Sherwood Place

Preliminary Stormwater Report

PRELIMINARY STORMWATER AND EROSION CONTROL
BECKER SUBDIVISION

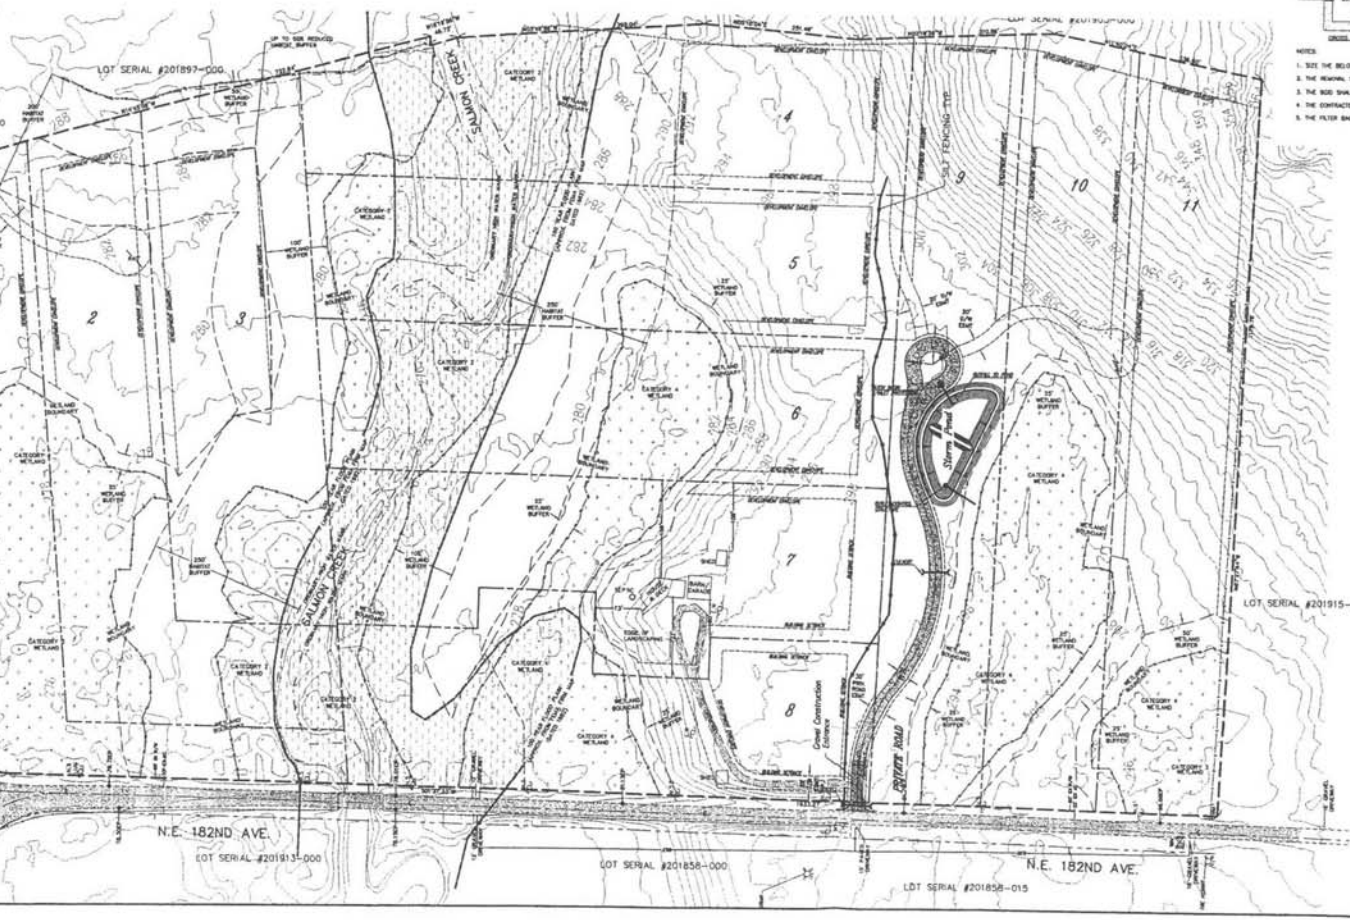
Plan must be stamped, dated, and signed
